CLAREMONT BUSINESS PARK 2 FIL. NO. 1 - LOT 5

EL PASO COUNTY, STATE OF COLORADO
GRADING & EROSION CONTROL PLAN

EPC STORMWATER REVIEW COMMENTS
IN ORANGE BOXES WITH BLACK TEXT

GRADING & EROSION CONTROL PLAN
CLAREMONT BUSINESS PARK 2 FIL. NO. 1 – LOT 5
JOB NO. 44-037
DATE PREPARED: JULY 17, 2020
DATE REVISED: SEPT 4, 2020

FOR BURIED UTILITY INFORMATION
48 HRS BEFORE YOU DIG
CALL 1-800-922-1987

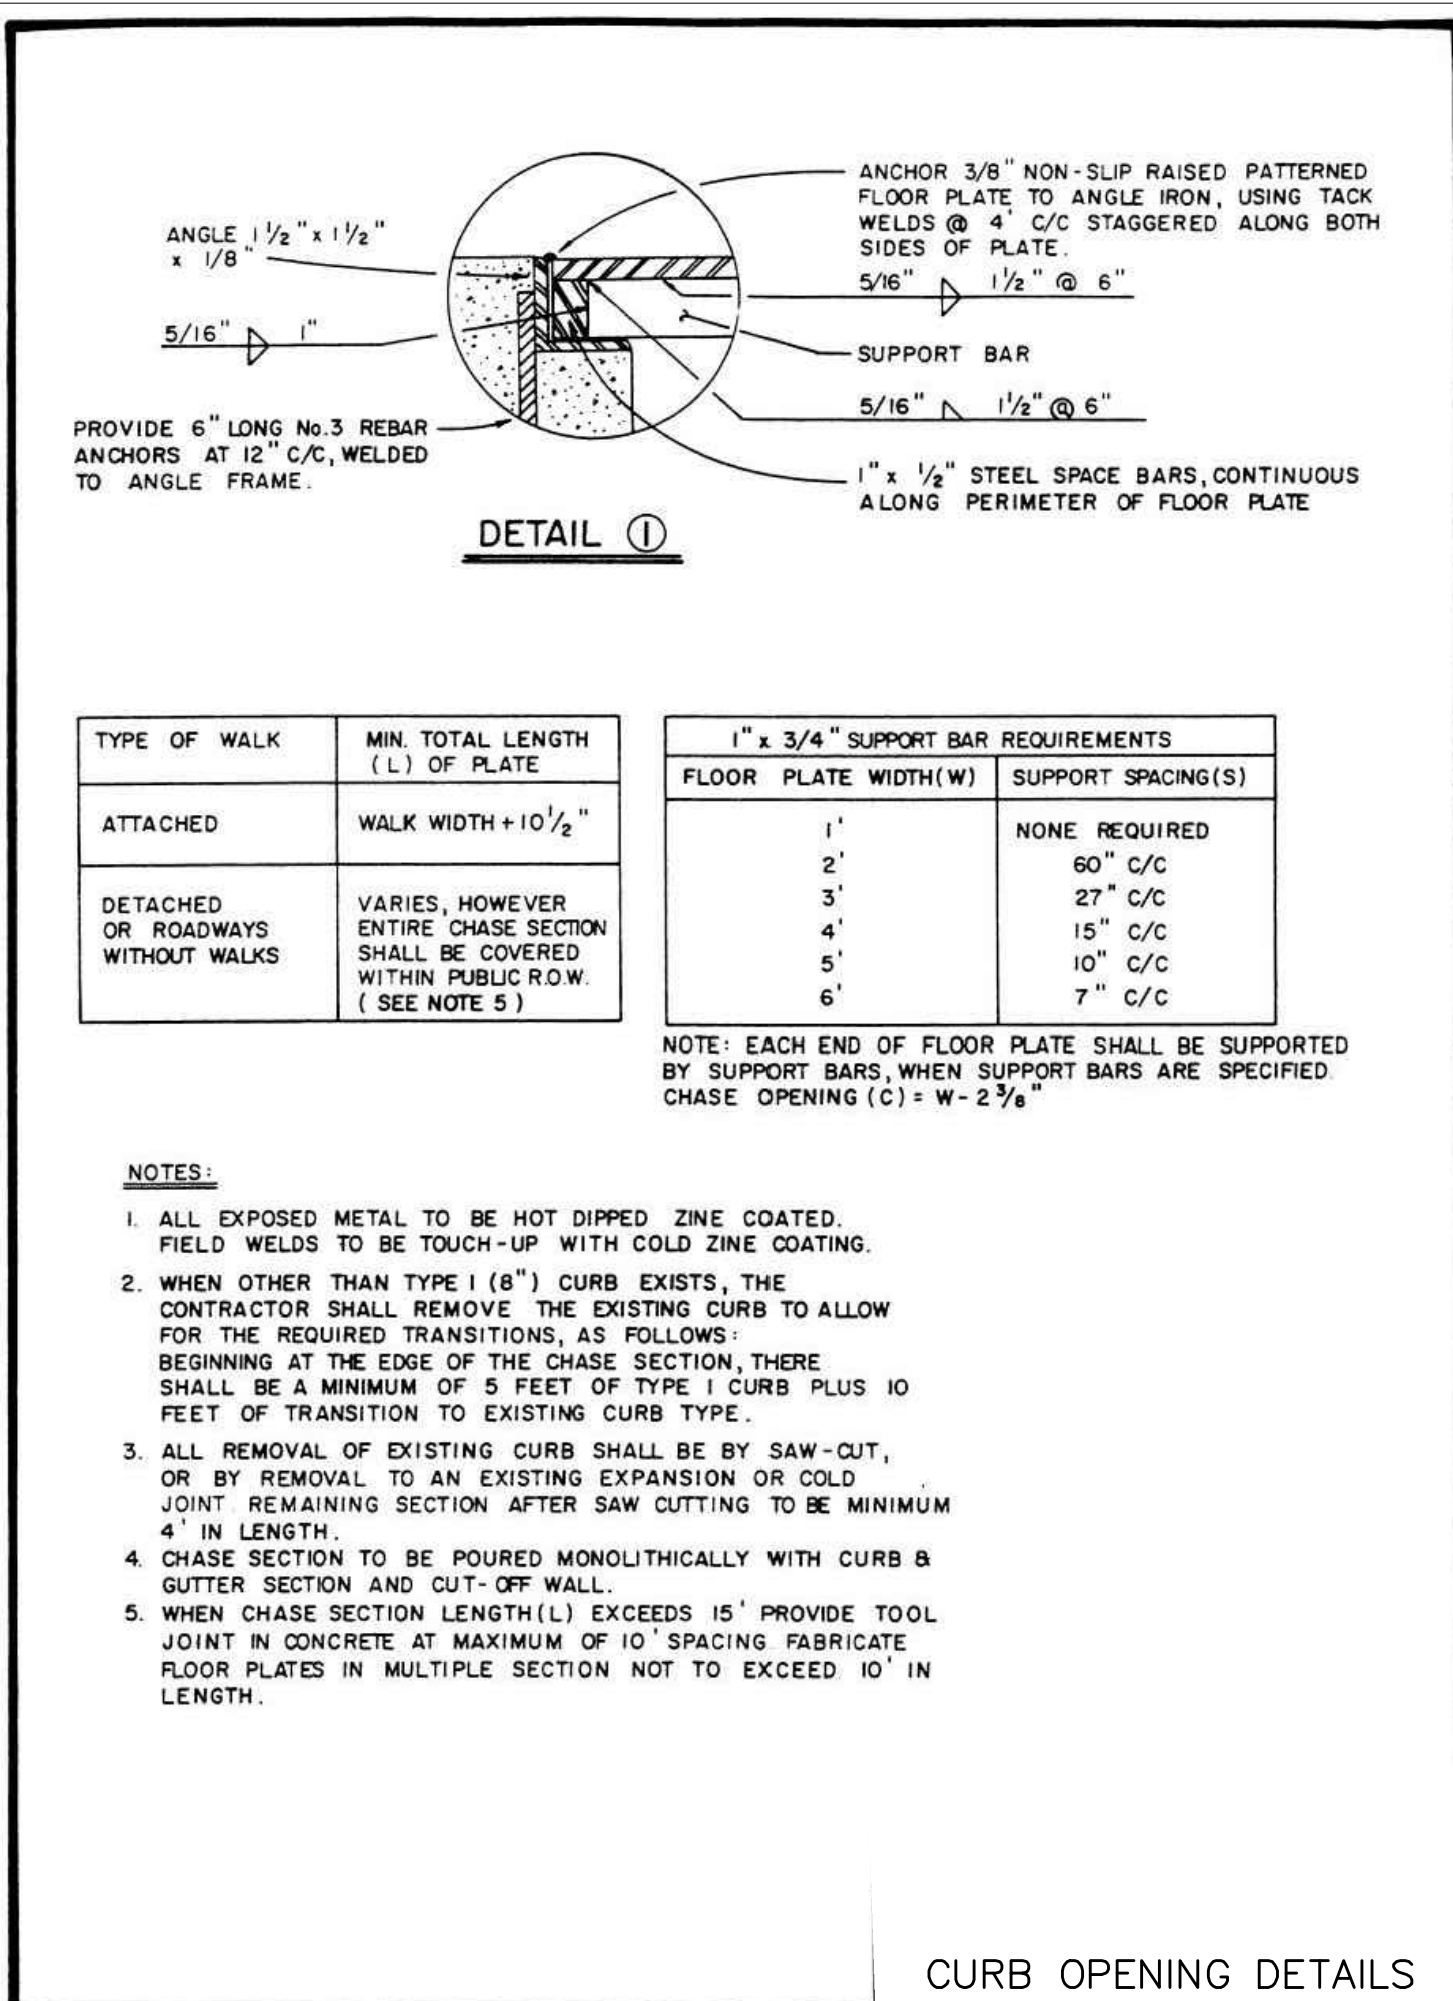
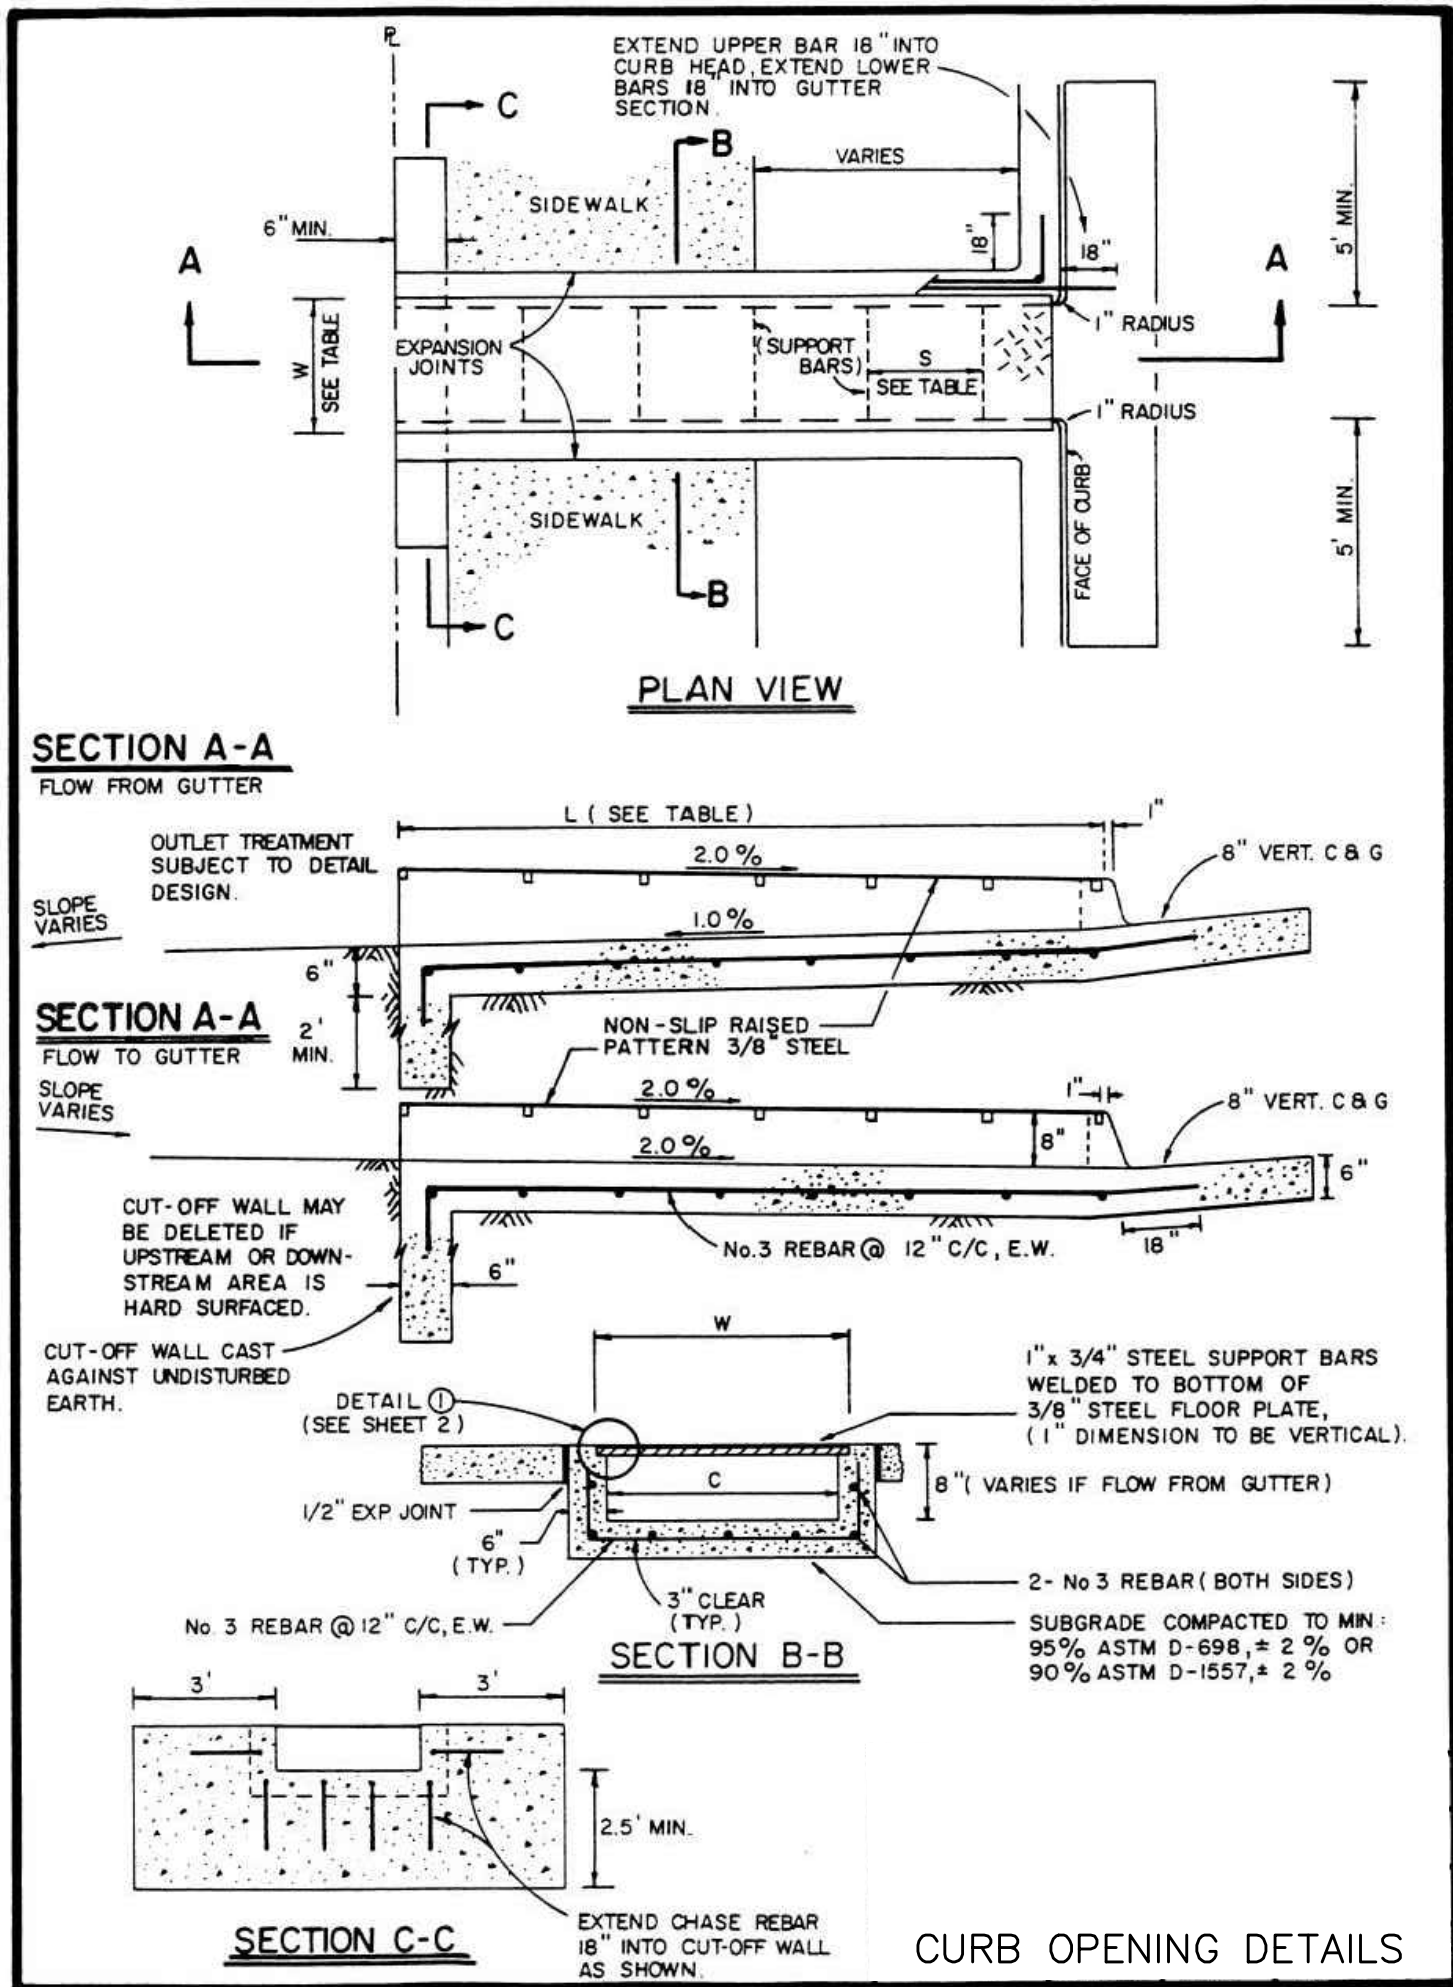
include details for CWA, Seeding/Mulching, SF, SSA, and VTC (w/ min 75ft length)

Details added as requested see sheet 4
